AMERICAN SUZUKI MOTOR CORPORATION

Subject: Recall Campaign No. 07V-148

4-STROKE
BULLETIN NO. VS/VX/VZ/VL NO. 51
DATE: 4/3/2007

**SAFETY RECALL CAMPAIGN
VZR1800K6 & VZR1800/ZK7 (M109R)
FUEL DELIVERY PIPE REPLACEMENT
CAMPAIGN #2096**

Blue paint mark

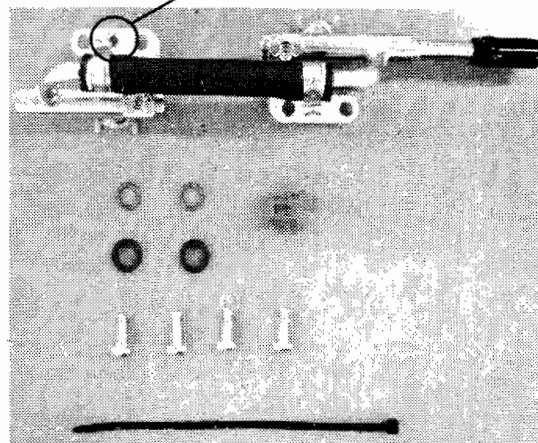
NOTE: The replacement fuel delivery pipe assembly has a blue paint mark as shown.

Fuel Delivery Pipe Assembly Kit Part# 99103-11225 Dealer Net: \$105.77

Part No.	Part Name	Qty
15730-48G01	Pipe Assy, Delivery	1
15717-16G00	O-ring	2
15722-29G00	Seal	2
13602-06148	Screw	4
09407-14407	Clamp, wiring harness	1
	Retainer, fuel hose connector	1

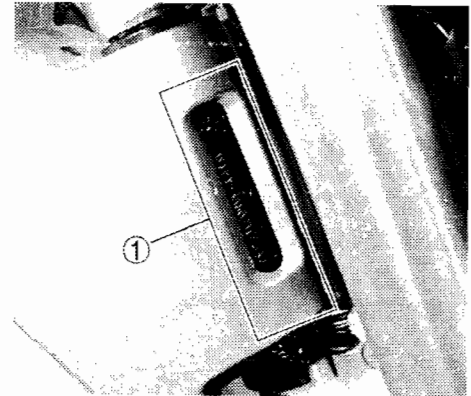
DO NOT reuse the original fuel hose connector retainer. Confirm that the fuel hose connector has completely seated and locked (clicked) into position before turning on the ignition switch.

- 5) Connect the fuel injector couplers Ⓐ and clamp the injector harness to the fuel delivery pipe.

- 6) Connect the fuel tank, remove the shop rags from over the bore of each throttle body, and run the engine, checking for fuel leaks.
